DOCKET NOS. 50-266 AND 50-301
RESOLUTION OF NRC CONCERNS REGARDING THE
CONTROL ROOM DESIGN REVIEW PROGRAM PLAN
POINT BEACH NUCLEAR PLANT, UNITS 1 AND 2

RESPONSE TO NRC CONCERNS REGARDING
THE POINT BEACH NUCLEAR PLANT
CONTROL ROOM DESIGN REVIEW PROGRAM PLAN

FIGURE 4-1. HED ASSESSMENT FLOW

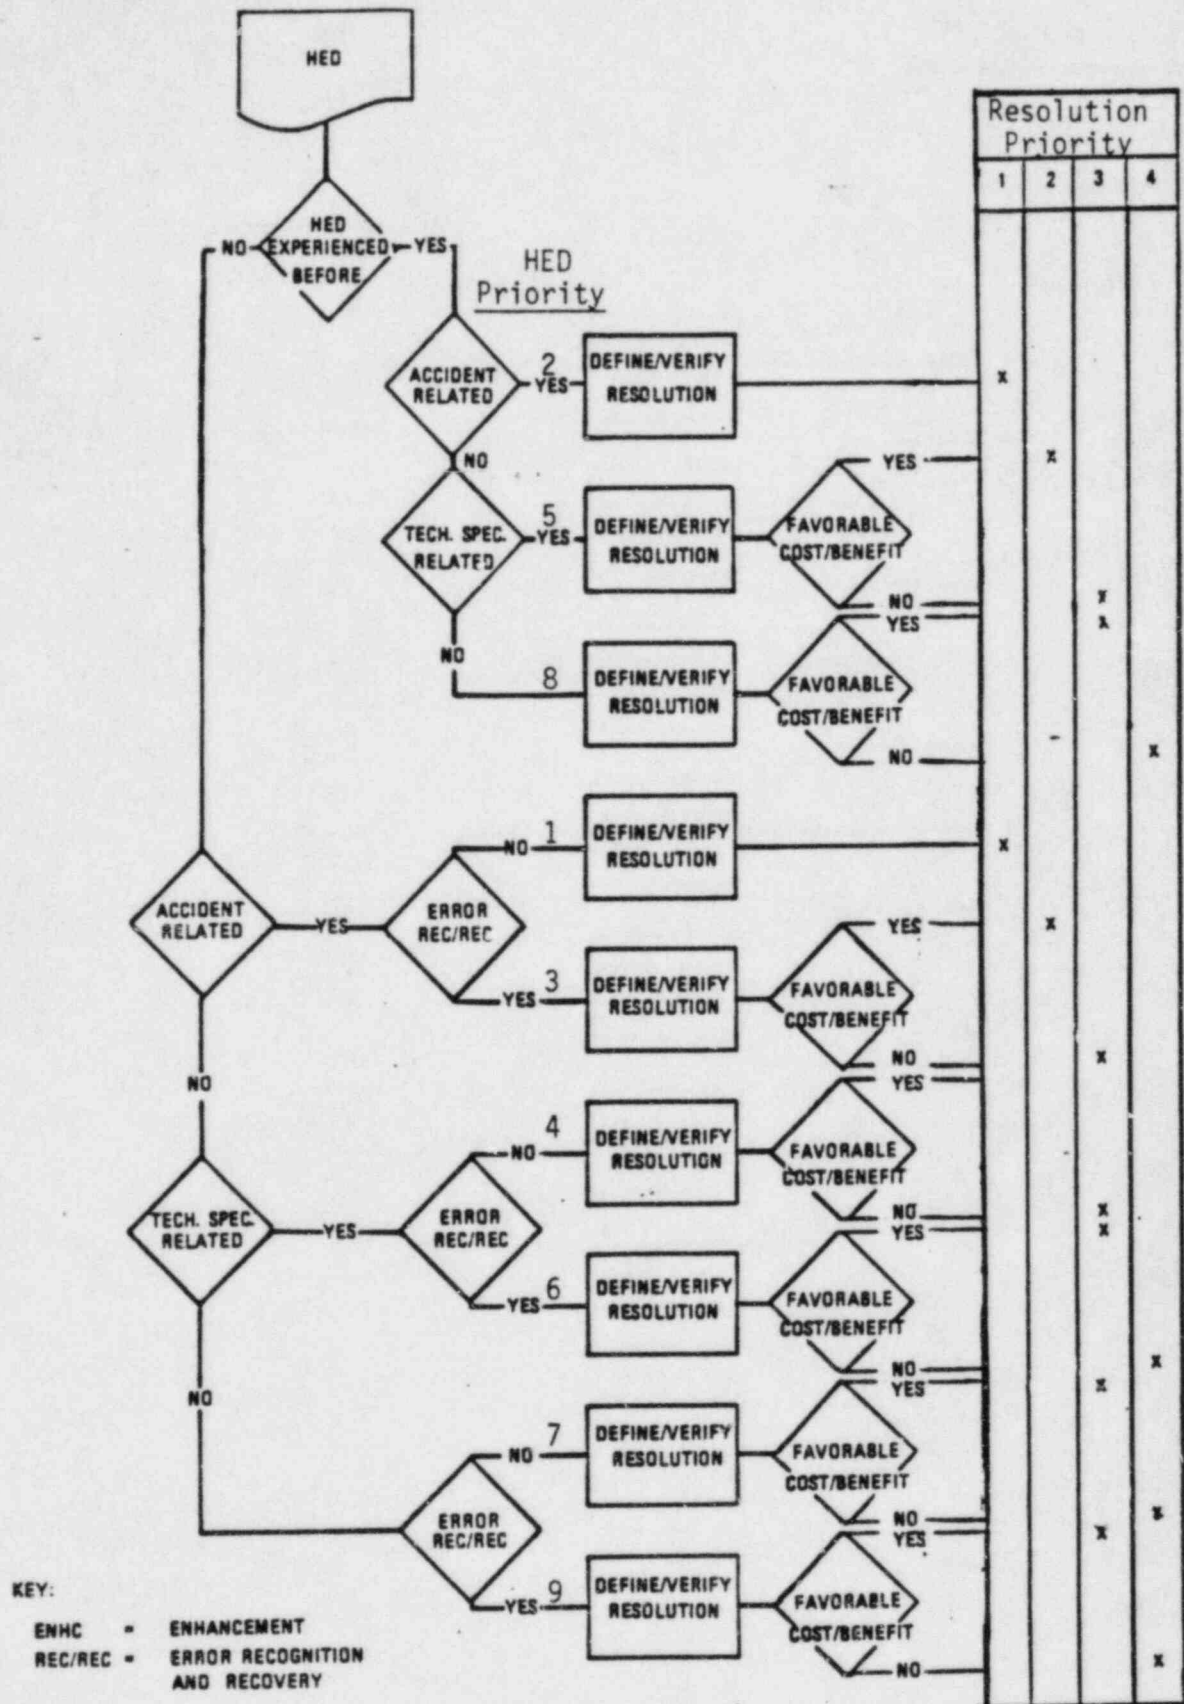
5. The Point Beach program plan assessment methodology does not describe what criteria will be used to determine the "accident-related potential" of an HED.

7. It appears that several of the criteria for determining the validity of a HED could remove HEDs from consideration for correction without adequate assessment.

8. It appears that a cost/benefit analysis may be used as the sole basis for determining whether some HEDs should be corrected.

If a HED affects the performance of a task identified in the accident response-based SFRTA, it is considered to have "accident-related potential". Similarly, if a HED could result in violation of a Technical Specification, it is "Tech Spec-related" (see revised Figure 4-1). These criteria will be included in a revision of CRDR the program plan.

The methodology for screening of HEDs has been revised to eliminate the flow-path item which allows dismissal of a HED before it is adequately assessed for safety significance. All HEDs will be assessed for safety significance, i.e., accident-related and Tech Spec-related, per the attached revised flow chart (Figure 4-1). This assessment will be documented on the attached revised HED record form.

As noted above, the methodology for HED assessment has been revised. While in some cases the NRC concern is accurate, it should be noted that a cost/benefit analysis alone does not result in non-implementation for a number of HED evaluations. Assignment of dollar values to "benefits" is very subjective. Hence, while a higher cost than benefit situation may occur, the HED may still be corrected. For example, all accident-related HEDs have a resolution priority of 1, 2, or 3 and should be corrected. This will occur as a result of the "HED priority" screening to be done under the revised methodology. See attached HED assessment flowchart (Figure 4-1) and attached revised HED record form.
